SERVICE BULLETIN

BULLETIN # 03-03

SUBJECT: 42 CONVERTIBLE STEERING CLEVIS PINS

HULL #s: #31 THRU #170

CLEVIS PIN

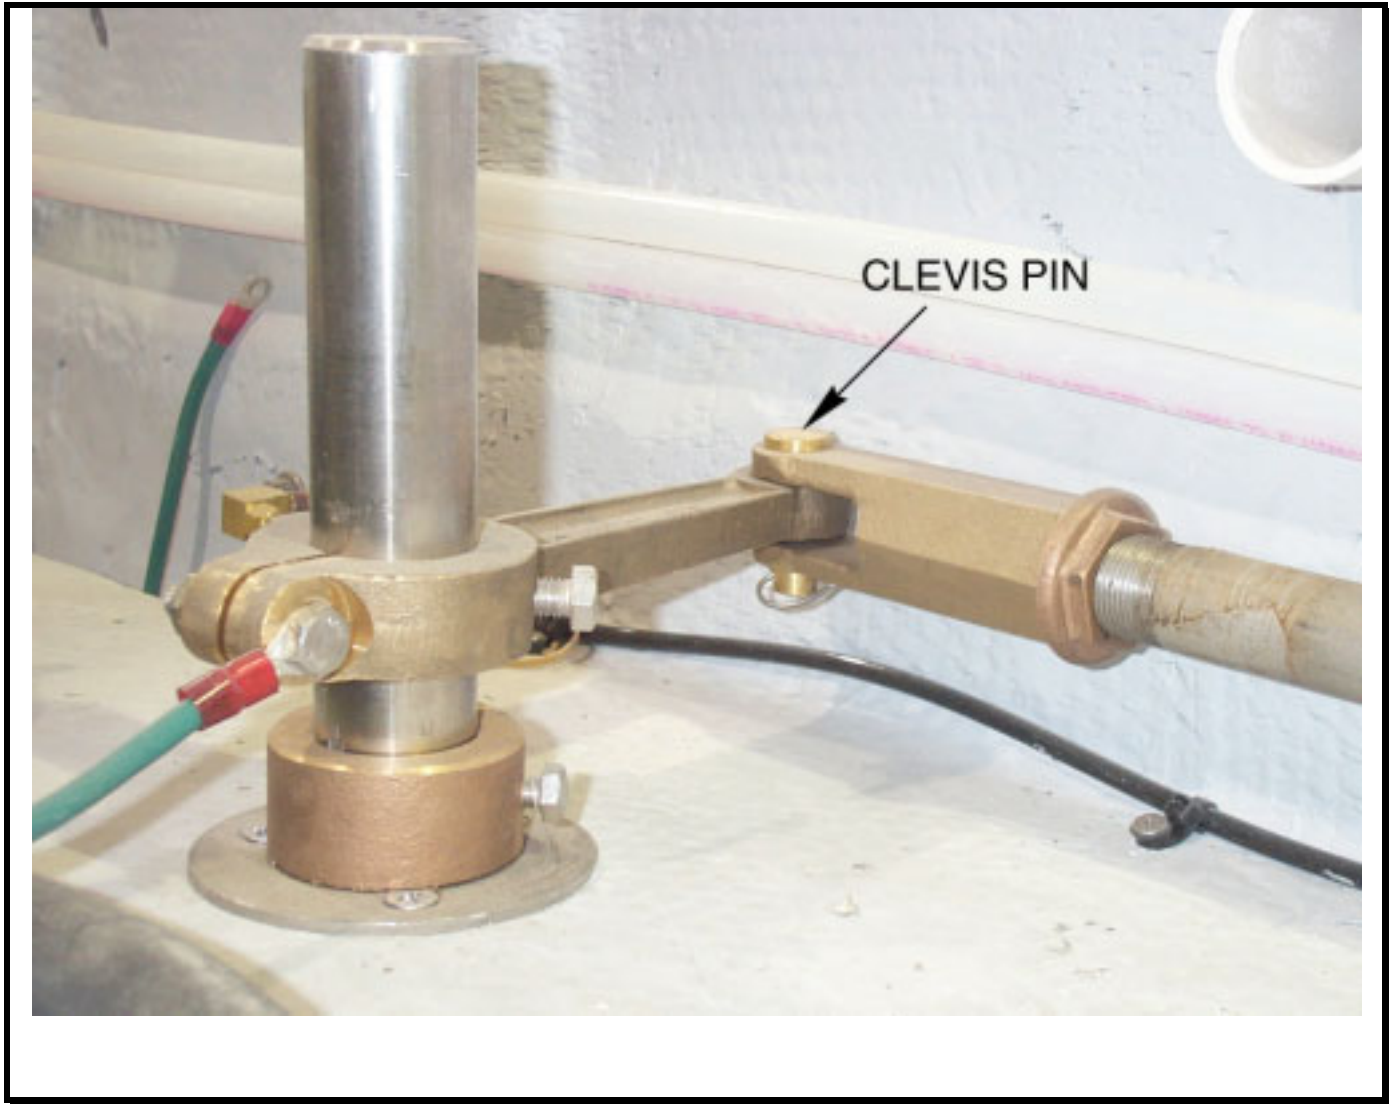
It has come to our attention that the steering clevis pins on certain 42 convertibles have shown excessive wear. Because this system has a large affect on the handling and performance of the boat we recommend the following repairs be done as soon as possible.

The original brass clevis pins need to be replaced by a new stainless steel clevis pin with a nylon bushing. All parts should be ordered thru the customer service department.

- 2 ea. Stainless clevis pins
- 2 ea. Nylon bushings
- 2 ea. 1 ¼ X 1/8" Cotter pin
